ROCKY REACH BIOLOGICAL OBJECTIVES 2013 STATUS REPORT

Final Report

**ROCKY REACH HYDROELECTRIC PROJECT
FERC Project No. 2145**

June 26, 2014

Figure 5-1. Rocky Reach dam fishway half-duplex PIT tag antennas locations, RR01-RR07.

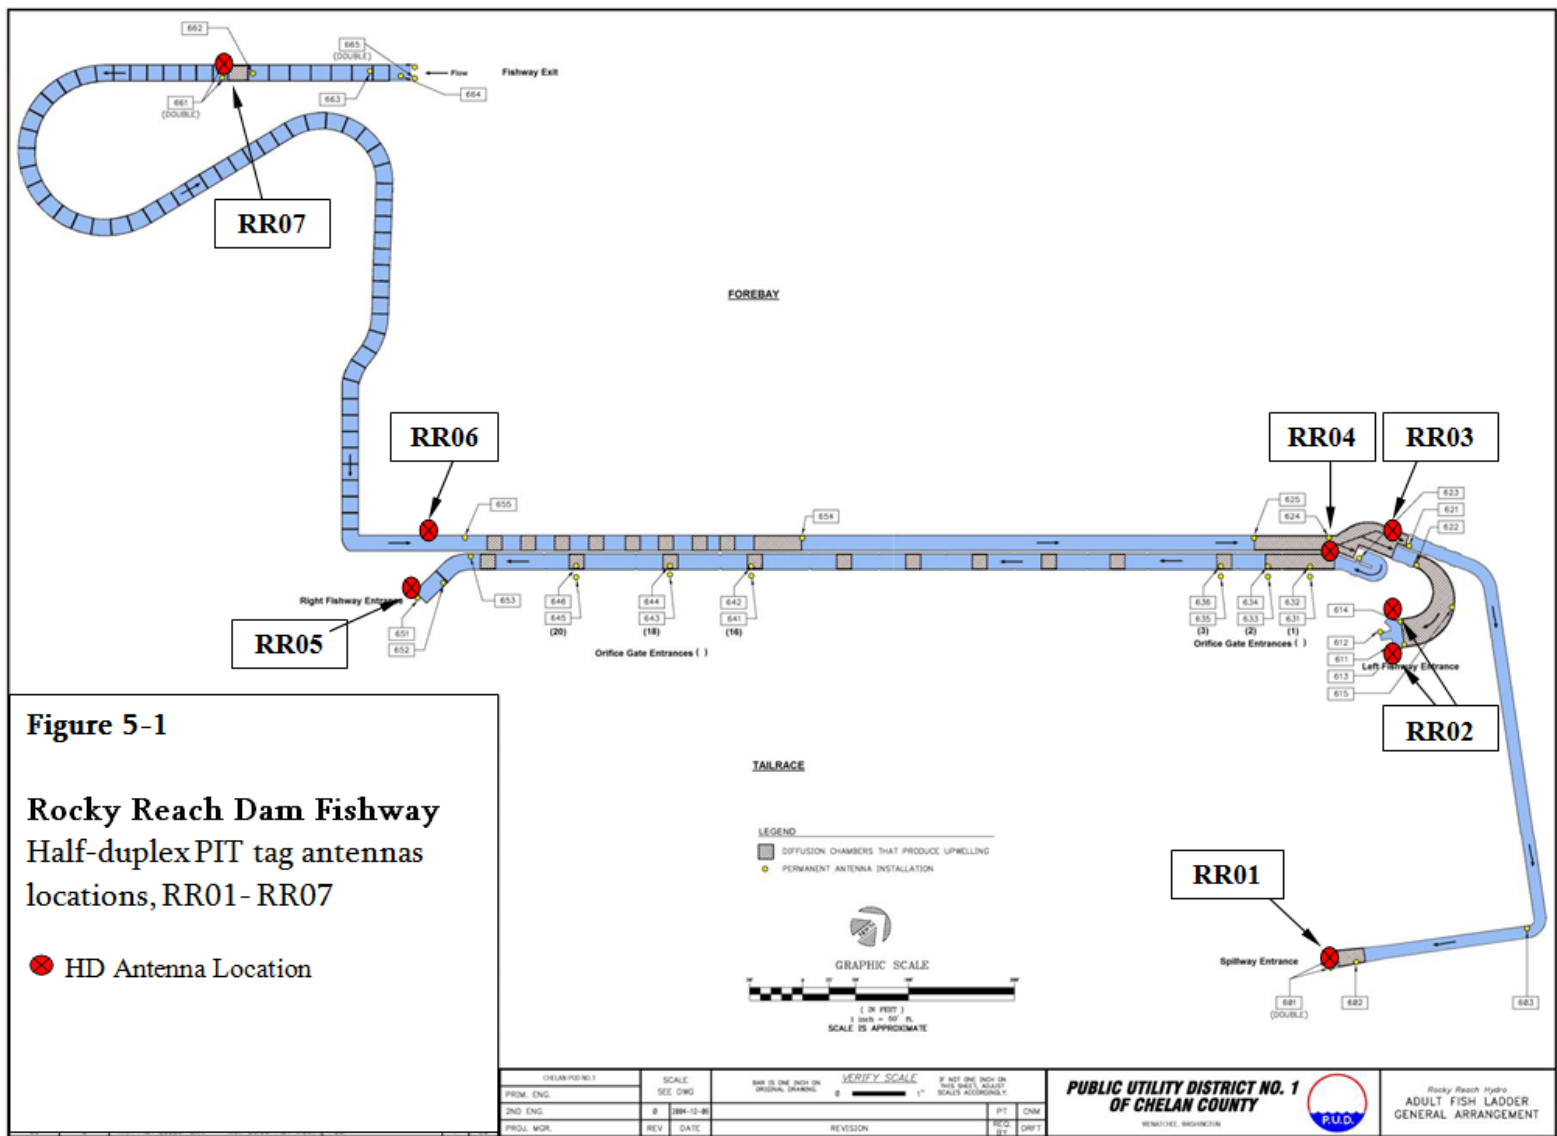
Commenting Agency	Agency Comment	Chelan PUD Response
YN 2/21/14 Draft Report comments	Section 5, Page 28. In general, a picture of the locations of the arrays would be very helpful in following this discussion.	Diagram of Rocky Reach fishway and installed HD PIT tag antennas locations has been prepared and included in the revised report.
YN 2/21/14 Draft Report comments	Section 5, Page 28. Tables 5-2 and 5-3 contain essentially the same information, but one with considerable more detail than the other. It would be informative if 5-1 were the same as 5-2.	Table 5-1 reports physical locations of antennas in the Rocky Reach fishway. Table 5-2 and 5-3 contain tag passage data from individual fish in 2012 and 2013. We are unsure how to make Table 5-1 appear like Table 5-2 because they contain vastly different data. Detailed detection times and detection locations for 2012 adult passage were added to Table 5-2, as we believe that is what your comment intended to say.
